UNITED STATES PATENT AND TRADEMARK OFFICE

APPLICATION NO.	FILING DATE	FIRST NAMED INVENTOR	ATTORNEY DOCKET NO.	CONFIRMATION NO.
10/673,276	09/30/2003	Masahiro Nozaki	26E-003	1581

STRIMBU, GREGORY J

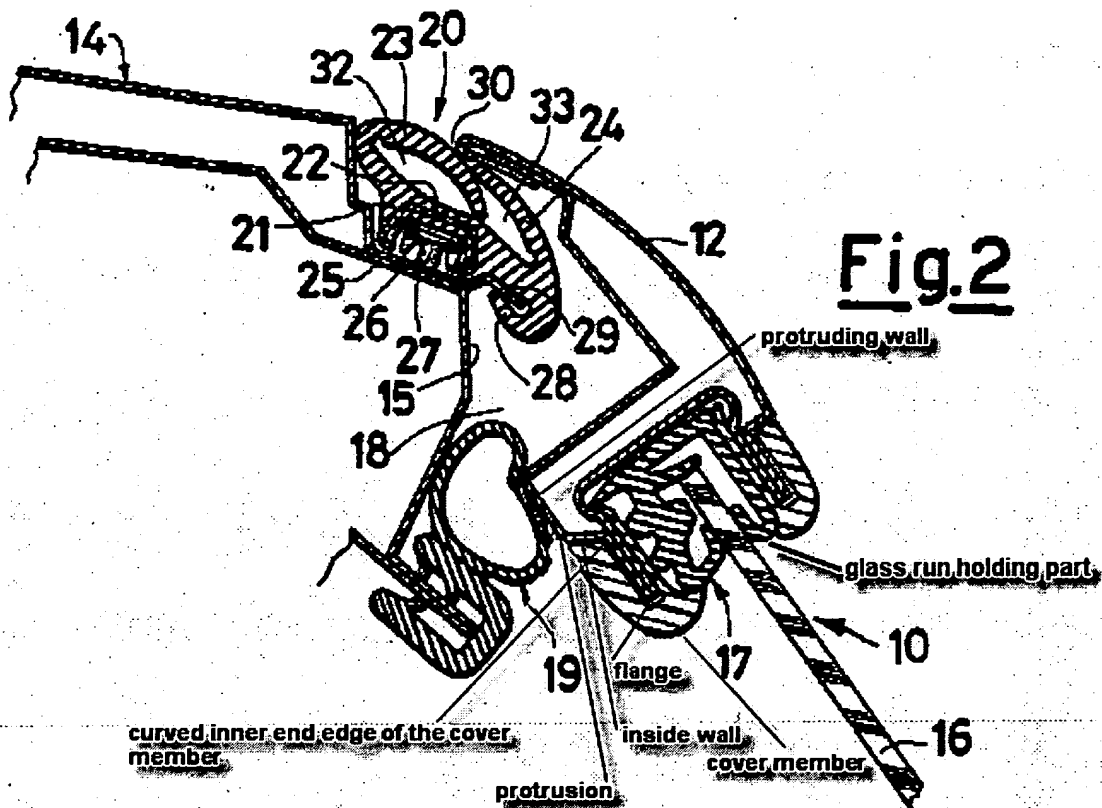
Claims 1, 8, 9 and 18 are rejected under 35 U.S.C. 102(b) as being anticipated by Villa et al. Villa et al. discloses a door seal structure in combination with a door frame 12 of a vehicle door 10 for sealing between a door opening portion (not numbered, but shown in figure 2) of a vehicle body (not numbered, but shown in figure 1) and the door frame, comprising an opening weather strip 19 adapted to be attached to the door opening portion, said opening weather strip including a tubular seal portion (not numbered, but shown in figure 2) which projects outwardly of the door opening portion, a glass run 17 for guiding a door glass 16 that is raised and lowered, said glass

run being held in a glass run holding part (not numbered, but shown in figure 2) provided along an inner peripheral portion of the door frame, a protrusion (not numbered, but shown in figure 2 comprising the portion of the door frame extending generally downwardly and to the left lower corner as shown in figure 2) in the door frame, wherein the protrusion protrudes inwardly of said glass run holding part since it extends inwardly of the glass run holding part, an inner peripheral end of said protrusion being joined to an inner side wall of said glass run holding part to define a flange (not numbered, but shown in figure 2), said protrusion including a protruding wall (not numbered, but comprising the part of the protrusion engaging the weather strip 19 as shown in figure 2) and an inside wall (not numbered, but shown in figure 2 spanning the distance between the protruding wall and the flange), said protruding wall being adapted to contact and press said tubular seal portion of said opening weather strip and said inside wall being located to face a vehicle compartment when the vehicle door is closed, said inside wall of said protrusion having a depression (not numbered, but shown in figure 2 where the inside wall transitions to meet the flange) that is formed immediately adjacent to said protruding wall so as to extend in a longitudinal direction of said protrusion, and a cover member (not numbered, but shown in figure 2 extending over the flange and extending into the depression) that extends to cover said inside wall of said protrusion of the door frame, an outer end edge of said cover member covering said flange and being connected to said glass run and an inner end edge of said cover member (not numbered, but comprising the portion of the cover member extending into the depression) being curved at an angle to an extending direction of said cover

member and being seated in said depression, wherein when the vehicle door is closed, said inside wall of said protrusion is substantially covered with said cover member such that said inner end edge of said cover member does not contact said tubular seal portion of said opening weatherstrip.

The applicant's comments concerning the inner end edge of the cover member not contacting the tubular seal portion are not persuasive because they are no more than mere supposition. Figure 2 of Villa et al. clearly discloses the inner end edge of

the cover member not contacting the tubular seal portion and accordingly anticipates the applicant's claimed invention.
